DEVELOPMENT REVIEW COMMITTEE (DRC) COMMENT REPORT

PROJECT NAME: Residence Inn Hotel

CASE NUMBER: R18054

REQUEST: Site Plan Level IV Review: 150 Room Hotel / Waterway Use / Associated Shared Parking Reduction

Sheet C1 Conceptual Site Plan

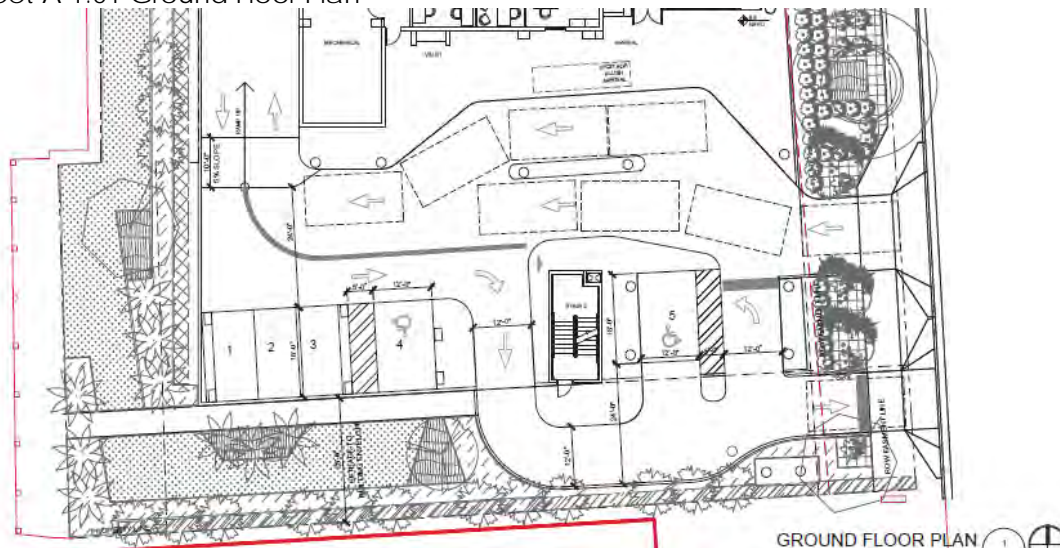
- f. Label all proposed pedestrian access/circulation areas: sidewalks, paths, crosswalks etc. (including width) to/from and within the site
- g. Correct discrepancies between C1 Conceptual Site Plan and A-1.01 Ground Floor Plan including the following:
 1. Location of ROW easement line
 2. Directional arrow for egress from the property
 3. Pedestrian crossing from disabled parking spaces.
 4. Number of vehicular reservoir spaces and vehicular reservoir space #7 on C1 which crosses the property line
 5. Driveway ramp dimensions and slope
